# Access Compliance Report

## Public Rights-of-Way

Intersection ID: 52582	Main Street: NOBLES_AV	Cross Street: N/A	Location: SW
ADA ID: B1B8B175C9DD	Ramp Type: Perp	Initial Pass/Fail: Fail	Overall Compliance: No
Severity Score: 1.25			
Codes/Mitigation Info/Possible Solution		Field Measurements/Component Compliance

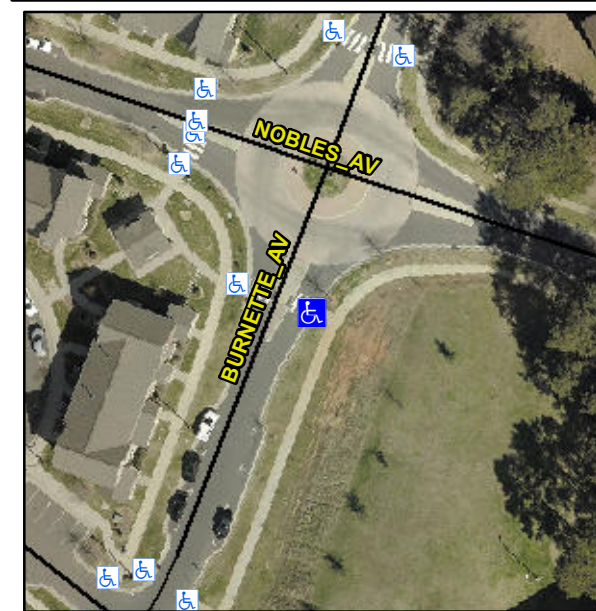
**Not Found, R304.5.3**

Compliance	Description	Data	Compliance	Description	Data
N/A	Ramp Length (in)	90.0	Yes	Ramp Slope (%)	5.7
Yes	Ramp Width (in)	72.0	No	Ramp XSlope (%)	3.1
N/A	Flare Type LT	N/A	N/A	Flare Type RT	N/A
N/A	Flare Slope LT (%)	N/A	N/A	Flare Slope RT (%)	N/A
N/A	Flare Traversable LT?	N/A	N/A	Flare Traversable RT?	N/A
N/A	Landing Length (in)	N/A	N/A	DWS Provided?	N/A
N/A	Landing Width (in)	N/A	N/A	DWS Contrast?	N/A
N/A	Landing Slope (%)	N/A	N/A	DWS Length (in)	N/A
N/A	Landing X Slope (%)	N/A	N/A	DWS Full Width?	N/A
N/A	Landing Curb? (Y/N)	N/A	N/A	DWS Offset (in)	N/A
N/A	Shared Landing?	N/A			
N/A	Gutter Ponding?	N/A	N/A	Gutter Slope (%)	N/A
N/A	Gutter Lip Ht (in)	N/A	N/A	Gutter X Slope (%)	N/A
N/A	Painted X Walk1?	Yes	N/A	Painted X Walk2?	N/A
	X Walk 1 Direction	To NW		X Walk 2 Direction	N/A
N/A	X Walk 1 Width (in)	118.0	N/A	X Walk 2 Width (in)	N/A
	X Walk 1 Slope (%)	4.1		X Walk 2 Slope (%)	N/A
	X Walk 1 X Slope (%)	4.2		X Walk 2 X Slope (%)	N/A

**Remove & Replace Entire Ramp.**
